SUBJECT: MCPC #24-0082-002
727-731 Montgomery Avenue SOPI Submission

SITE
MONTGOMERY AVENUE
MEDICAL OFFICE BUILDING
727-731 MONTGOMERY AVENUE, PENN VALLEY, PA 19072
LOWER MERION TOWNSHIP
MONTGOMERY COUNTY
TENTATIVE SKETCH PLANS
SKETCH PLAN
OWNER / APPLICANT
SARA HOLDINGS, LLC
808 MILL ROAD
BRYN MAWR, PA 19010
APRIL 2, 2024
1" = 10'
CCY
24-016
YOHN ENGINEERING, LLC
P.O. BOX 26094
COLLEGEVILLE, PA 19426
610-489-4580
WWW.YOHNENGINEERING.COM
1 of 3

Re: MCPC #24-0082-001
Plan Name: 727-731 Montgomery Avenue
(7,500 sq. ft. commercial on approximately 0.44 acres)
Situate: Montgomery Avenue (N); east of Woodbine Avenue
Lower Merion Township

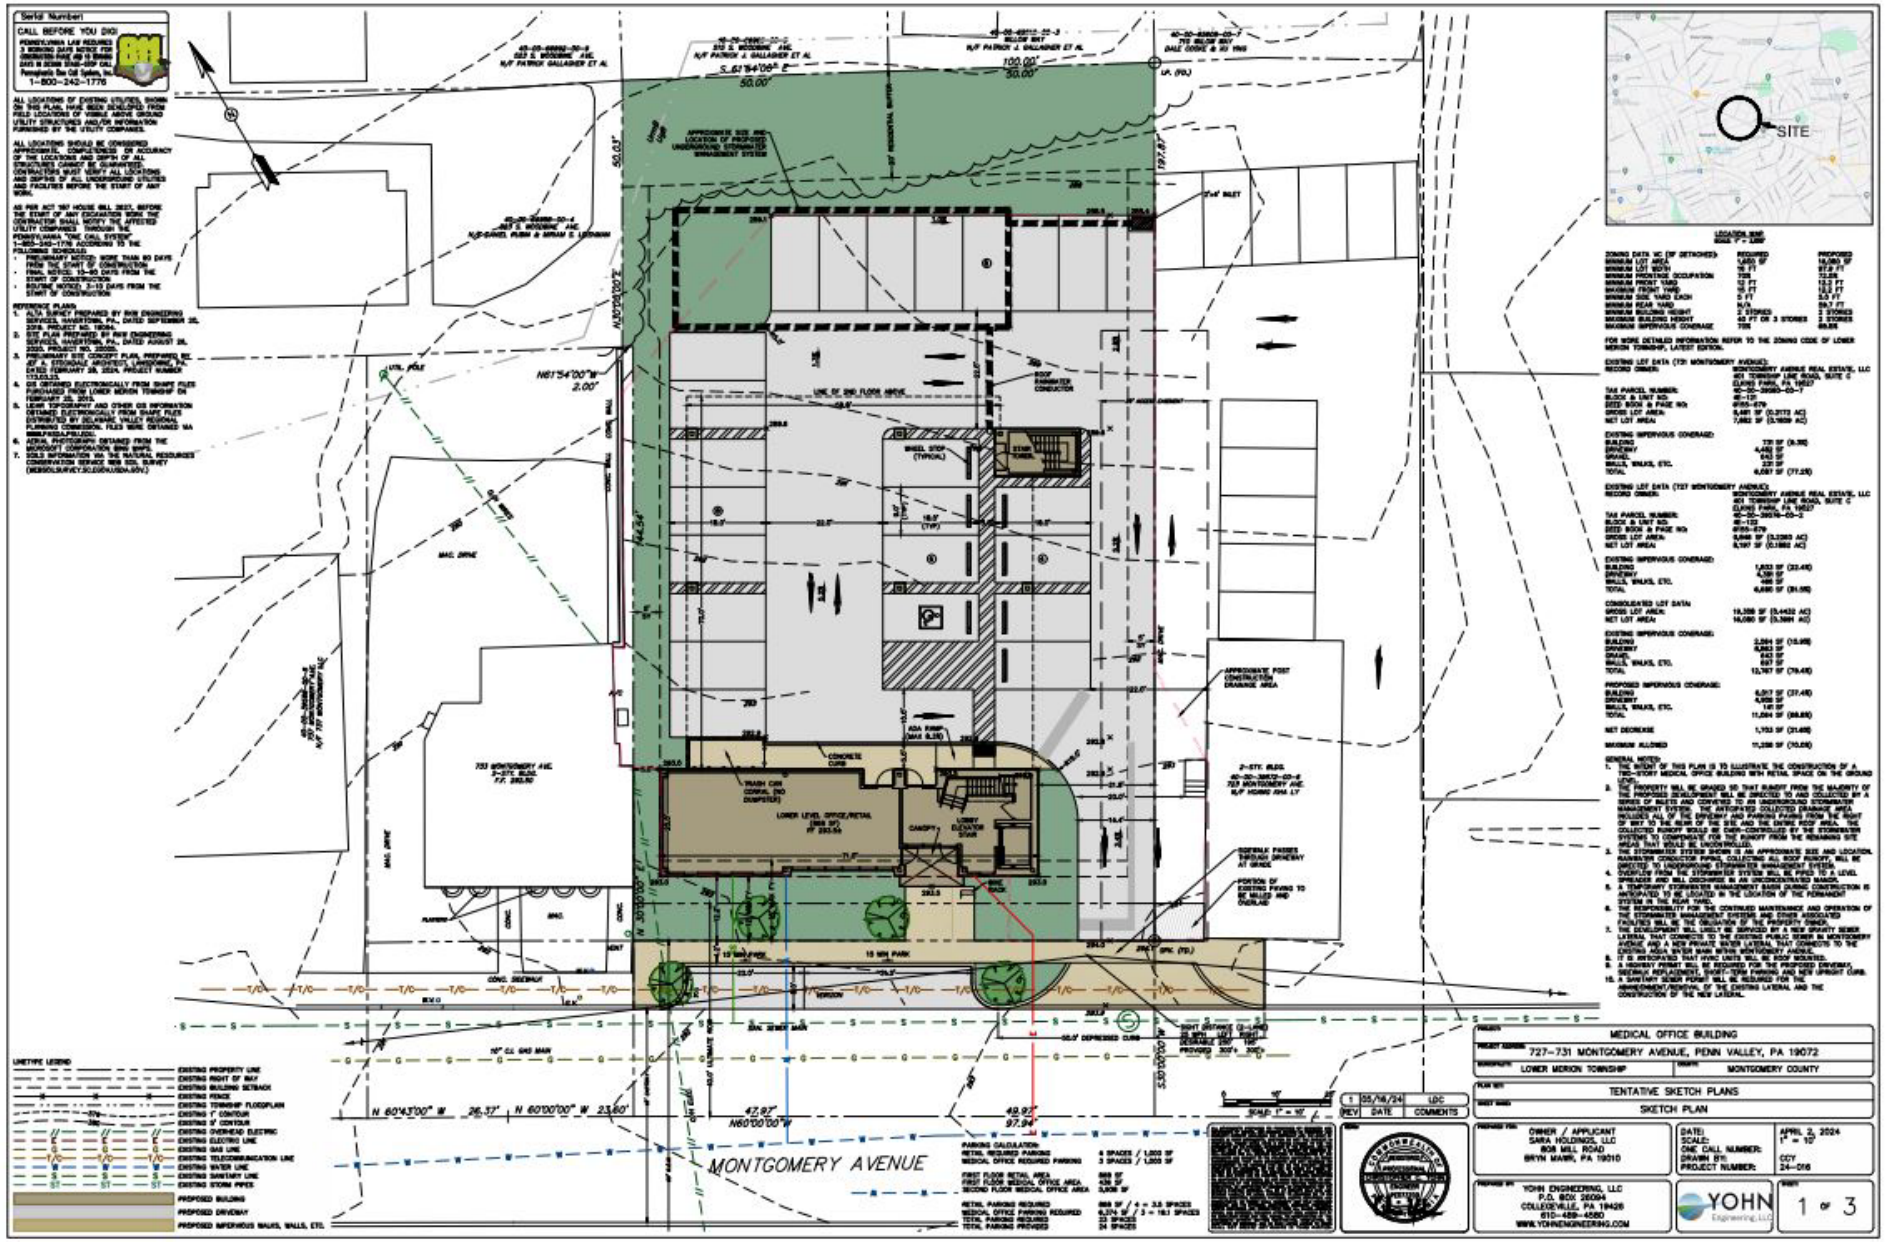
With the addition of an inset short-term parking area along the majority of the Montgomery Avenue frontage of the site, the proposed sidewalk width and lack of verge do not comply with the township's subdivision and land development ordinance (§135-4.9.C.(1)). We feel that the minimum 8-foot-wide sidewalk required by the township's subdivision and land development ordinance for primary arterial streets is very important for

pedestrian mobility along this busy corridor. We also wish to point out that the 4.2-foot sidewalk width appears to be further constrained by the placement of signage within the sidewalk area for the short-term parking spaces. We encourage the applicant to continue to work with the township to ensure the proposed streetscape design, including sidewalk width, street tree placement, and storefront design, will work together to create a development that will contribute to the walkable vision for the Penn Valley commercial area.

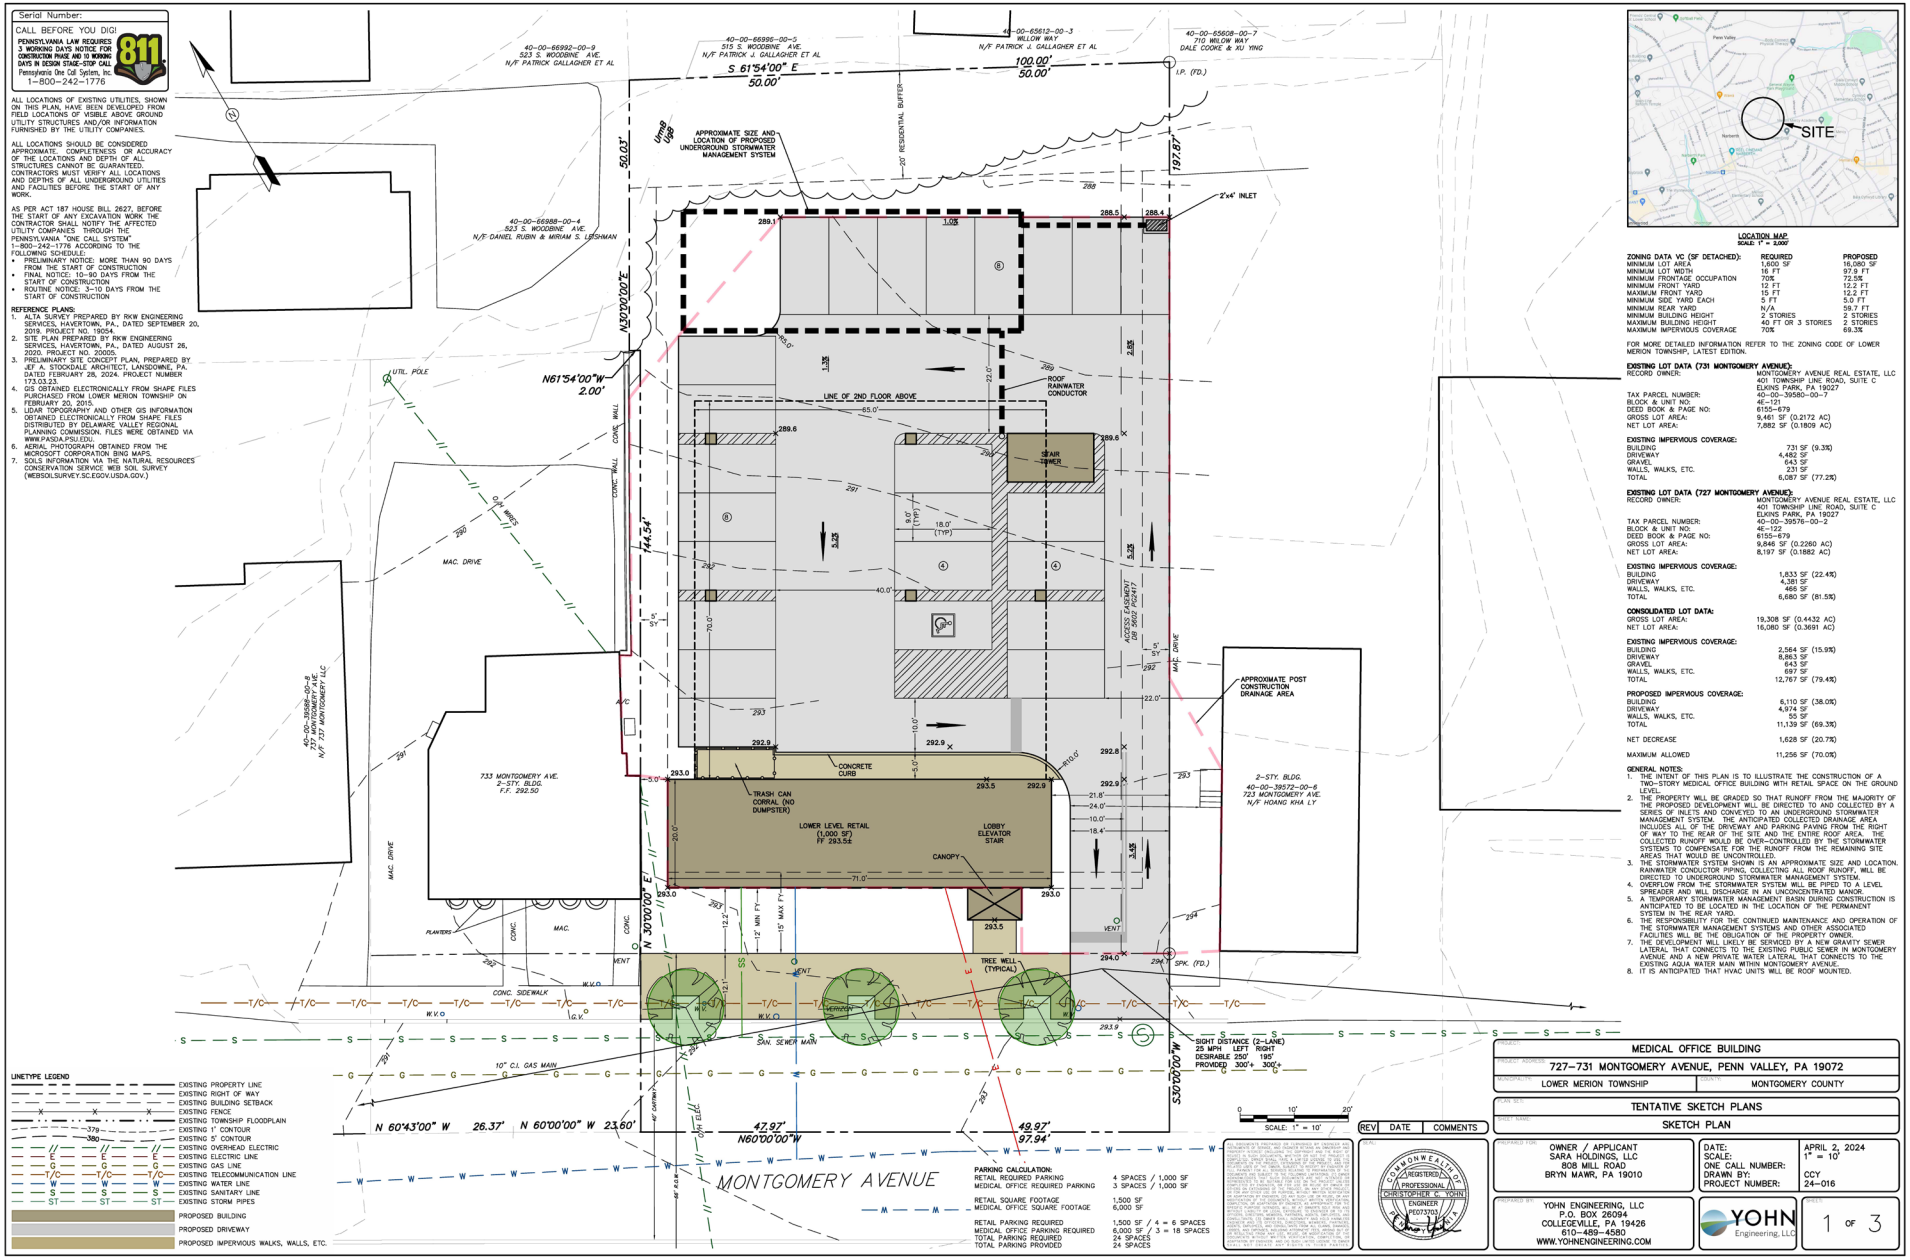
D. Parking Drive Aisle Width. Table 8.5.1. contains minimum parking lot dimensions. The parking lot drive aisle appears to narrow to approximately 12 feet in width in front of the four parking spaces closest to the driveway entrance. A drive aisle of 20 feet in width is required for a one-way, single-loaded drive aisle with perpendicular parking. If there is a reciprocal access easement on the adjacent property to the east that allows for this configuration, we suggest that it be clearly shown on the site plan.

A. Sidewalk across Driveway. Section 135-4.9.F.(2)(a) requires that "the grade and paving of the sidewalk shall be continuous across driveways." Future versions of the plan should be revised to show the grade and pavement material of the proposed sidewalk along Montgomery Avenue extending across the driveway.

C. Drive Aisle Width. Section 135-4.9.Q.(6)(b) states that "drive aisles along other nonresidential buildings shall be a minimum paved width of 22 feet, except where a dropoff/pickup lane is proposed." The one-way drive aisle along the rear portion of the building is only 10 feet wide.

D. Pedestrian Access within Parking Lot. Section 135-4.9.Q.(7) contains standards for pedestrian pathways and crosswalks that apply to all surface parking lots with 10 or more new parking spaces. The proposed site plan does not appear to provide a 5-foot-wide pedestrian pathway from the far end of the parking lot to the main entry of the building that is clearly separated from vehicular use areas.

E. Street Trees. Section 135-5.1.C.(7) states that street trees shall be planted at a rate of at least one tree per 30 feet of street frontage, or portion thereof. Based on the site's frontage length of 98 feet, four street trees should be provided; however, only three street trees are shown.

Section 135-5.1.C. requires that street trees either be planted in tree pits of at least 5-feet by 5-feet or within a verge of at least 6-feet in width. It does not appear that the proposed individual tree pit openings meet the minimum dimensions. We suggest that the four required street trees be planted in a continuous verge which can improve tree health, enhance natural rainwater infiltration, and serve to buffer pedestrians on the sidewalk from passing vehicular traffic.
